# Notice of Modification

## Section 75W of the *Environmental Planning and Assessment Act 1979*

The project approval (08\_0212) for the New Berrima Shale Quarry Project, granted by the Deputy Director-General, Development Assessment and Systems Performance as delegate of the Minister for Planning and Infrastructure on 6 July 2012.

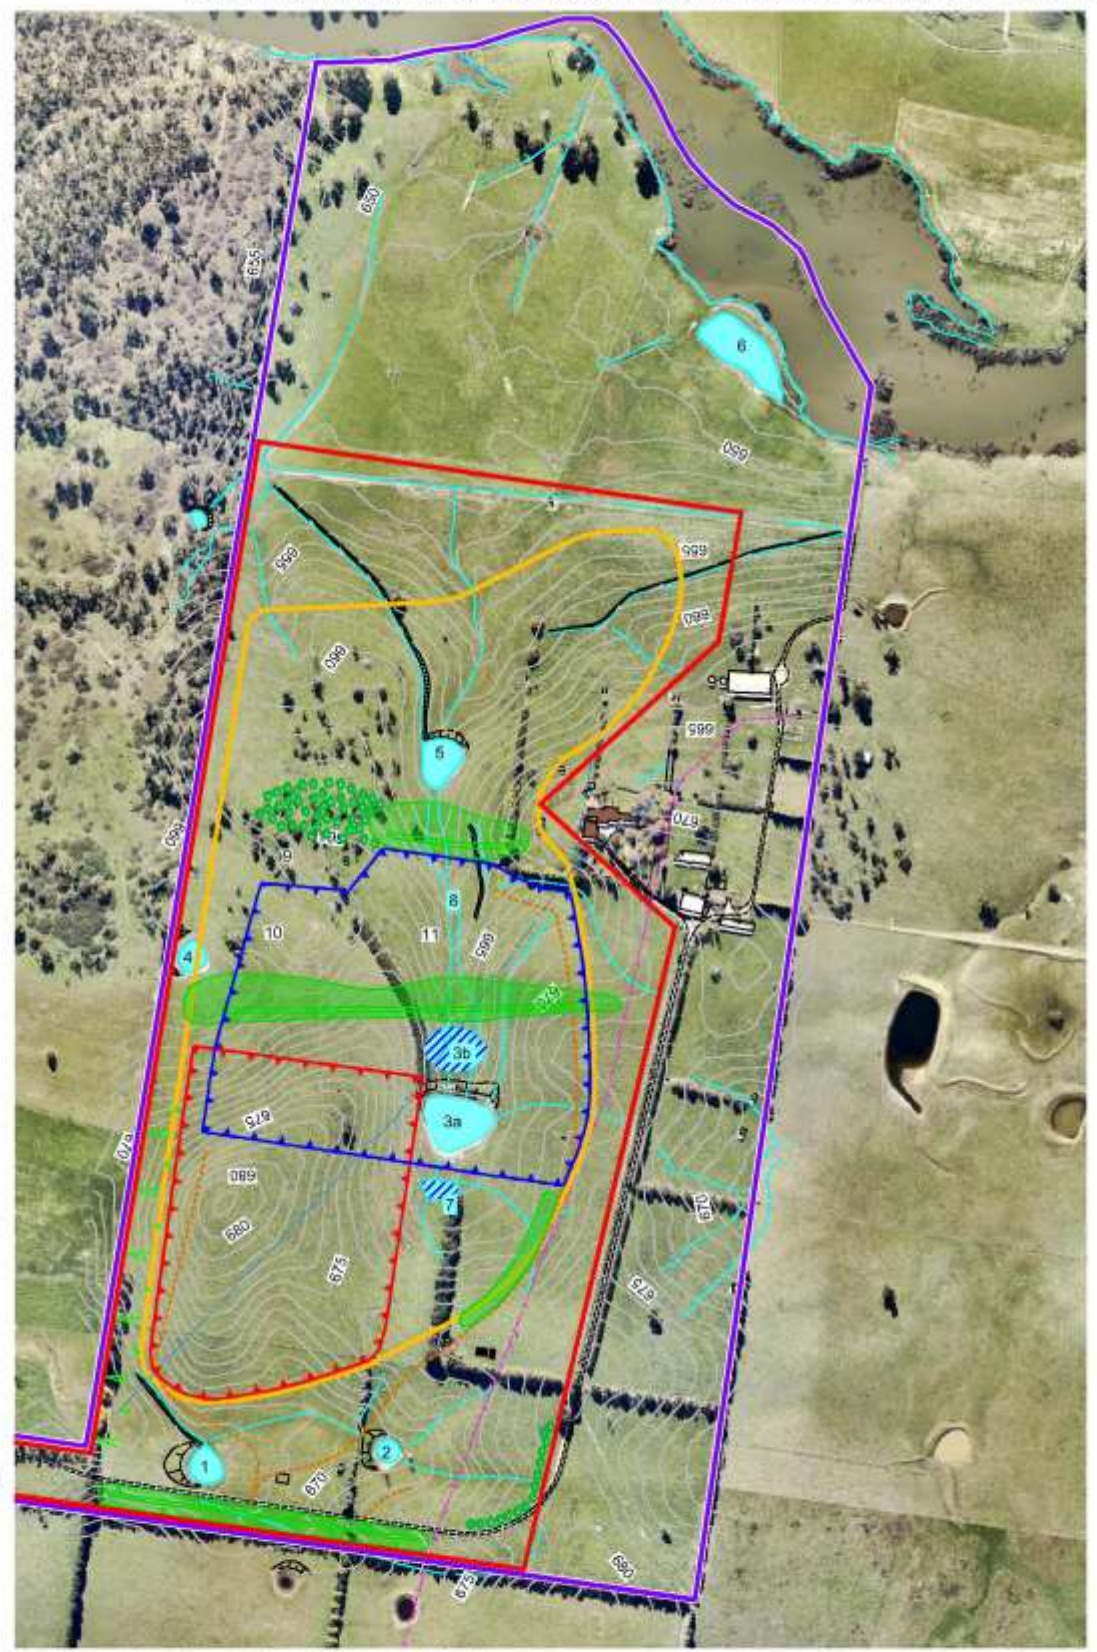
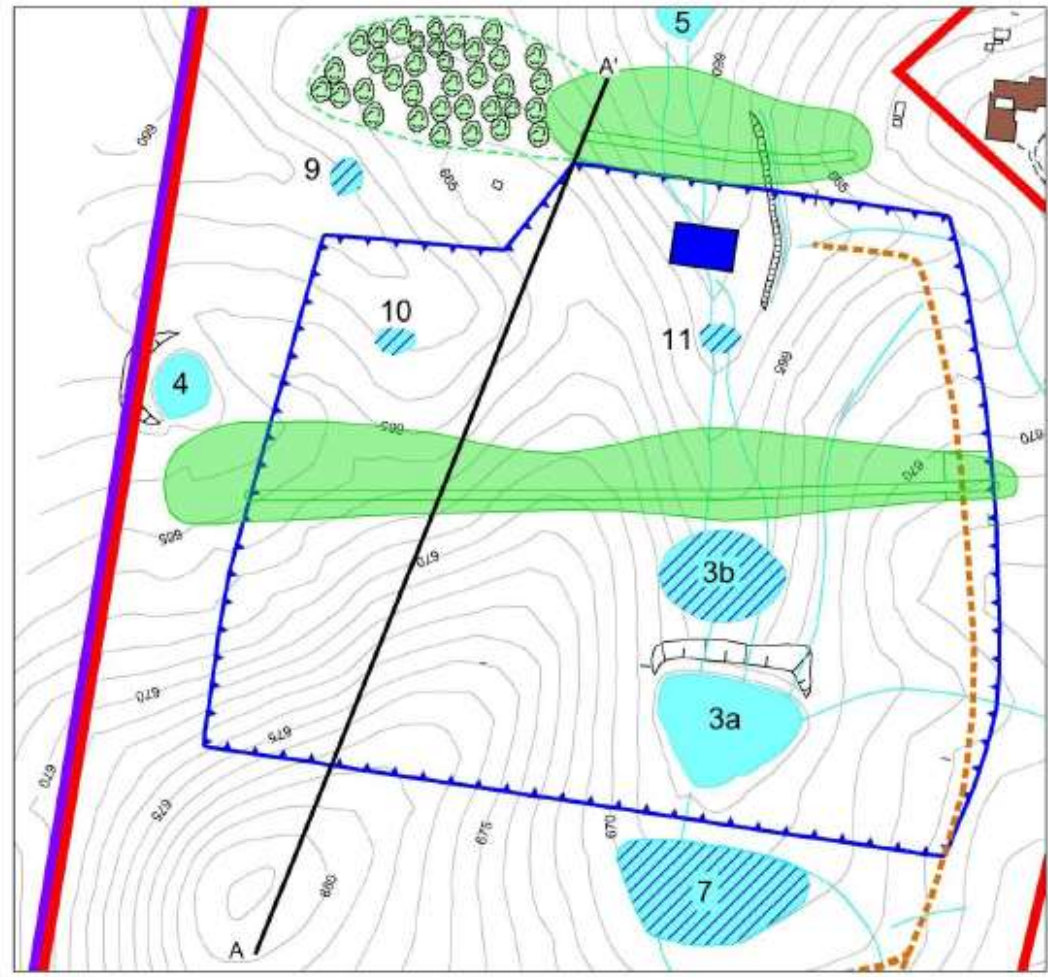
3A. The Visibility Barriers and surplus overburden stockpile (refer Figure 1 Appendix A) must be constructed to meet the dimensions specified in Table 1A, unless the Secretary agrees otherwise.

<b>Structure</b>	<b>Height</b>	<b>Base Width (m)</b>	<b>Length (m)</b>	<b>Surface Area (ha)</b>
Central Barrier ( <i>minimum</i> )	675 (m AHD)	30 - 45	420	1.5
Northern Barrier ( <i>minimum</i> )	672 (m AHD)	35 - 50	160	0.7
Southern Barrier ( <i>minimum</i> )	4 metres above the natural land surface	20	350	0.7
Overburden Stockpile ( <i>maximum</i> )	683 (m AHD)	-	-	-

19A. Prior to transporting any product from the site, the Proponent shall establish a 0.68 ha tree screen adjacent to the Northern Visibility Barrier, as shown on Figure 1 in Appendix A. The screen shall include native plant species from the *Southern Highlands Shale Woodland Endangered Ecological Community*.

21. Delete Figures 1, 2, 4 and 5 (except their titles) from Appendix A and replace with the following.
